Ashton-Ravensworth Underground Mine Integration

**EPBC Act
Preliminary Documentation**

**MAIN TEXT
AND
ATTACHMENTS**

Figure 1. Overlay of predicted Project maximum drawdown in the Middle Liddell Seam on landform imagery

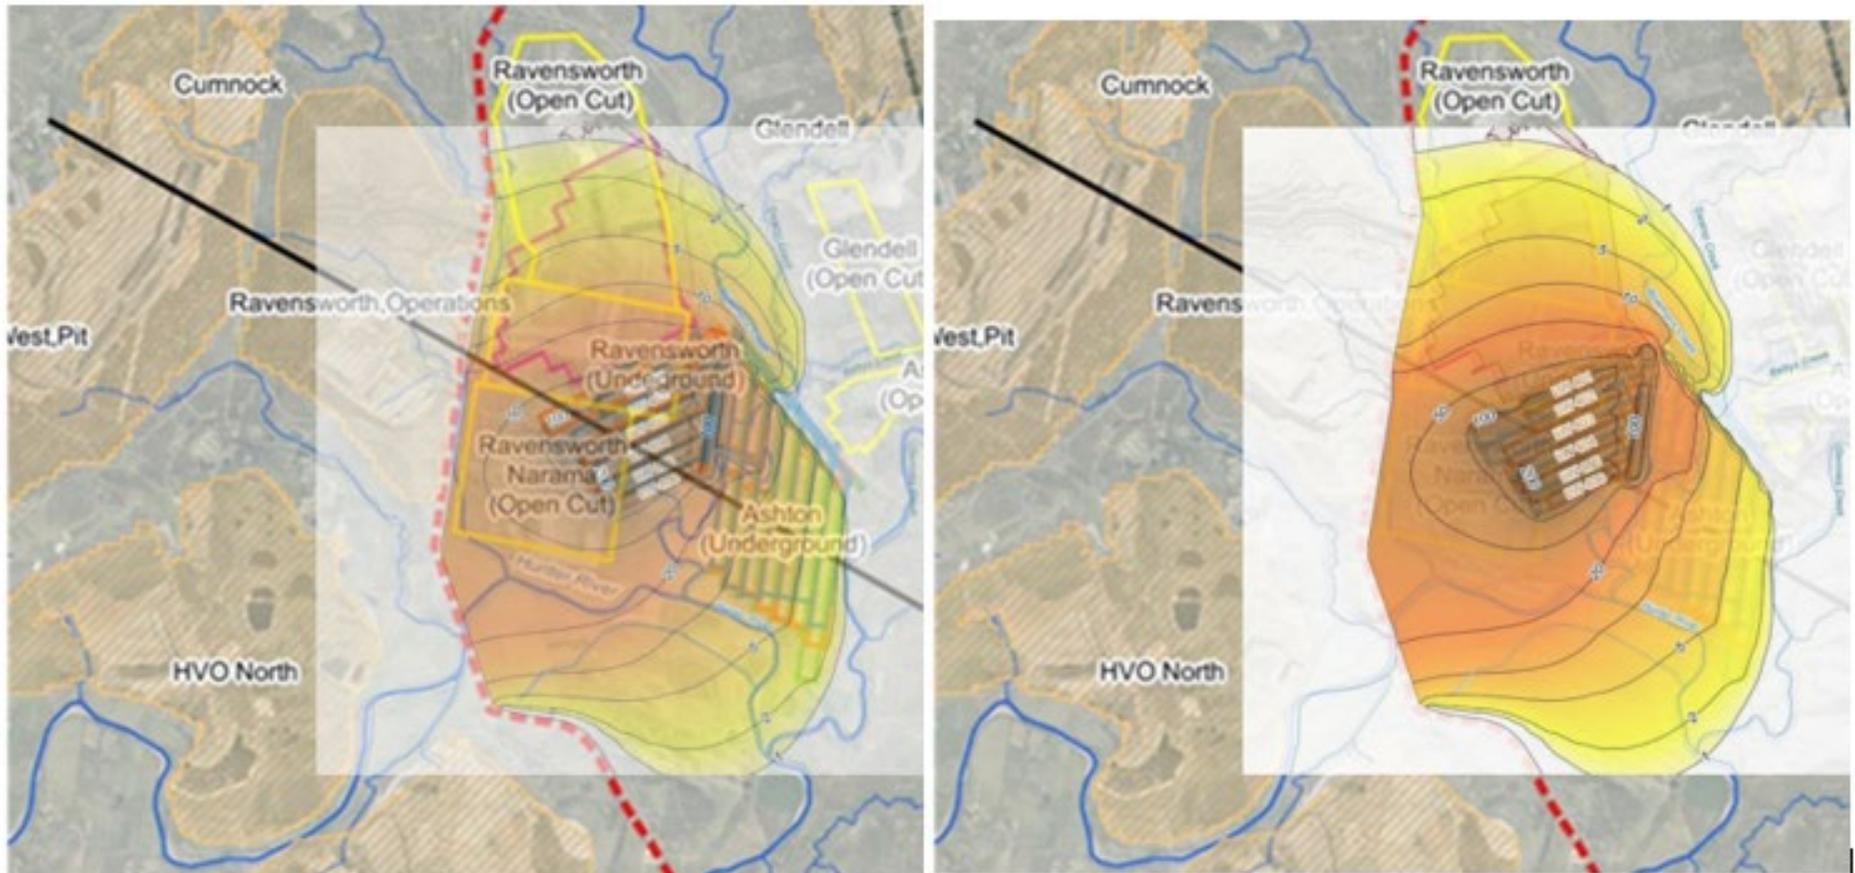
Figure 1 overlays the predicted Project maximum drawdown for the MLD Seam (model layer 14) on an image of district mining areas; the model boundary is marked by a dashed red line. **Figure 2** overlays the predicted cumulative maximum drawdown for the MLD Seam on the corresponding drawdown map from the more expansive Glendell model⁵. These overlays have been independently produced by the peer reviewer and confirm overlays produced by AGE. It is clear from the overlay that the drawdowns from the two models are consistent in the vicinity of the boundary of the smaller model. It follows that extension of the model farther west would have given no advantage, and that drawdowns predicted by the model would not be materially affected by edge conditions.
